BMW Motorrad USA

Service Information Bulletin

Technical Campaign

Subject: Shift Assistant

► Checking serial number for shift assistant

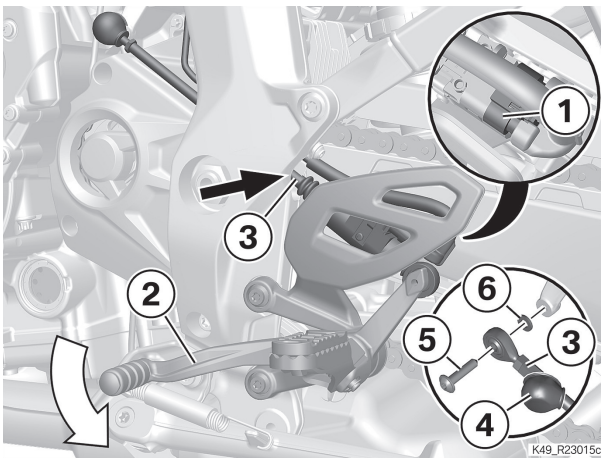
The shift assistant has to be replaced if both production date (1) and serial number (2) as stated on the shift assistant appear in the list below.

- Check production date **(1)** and production serial number **(2)**.
- List of affected shift assistants with production date **(1)** and production serial number **(2)**.

- 26.05.2015: 3-108
- 27.05.2015: 1-104
- 28.05.2015: 1-138
- 29.05.2015: 1-125
- 01.06.2015: 1-89
- 02.06.2015: 1-20
- 03.06.2015: 1-4

Production date and production serial number match the list of affected shift assistants.

- Renew the shift assistant.
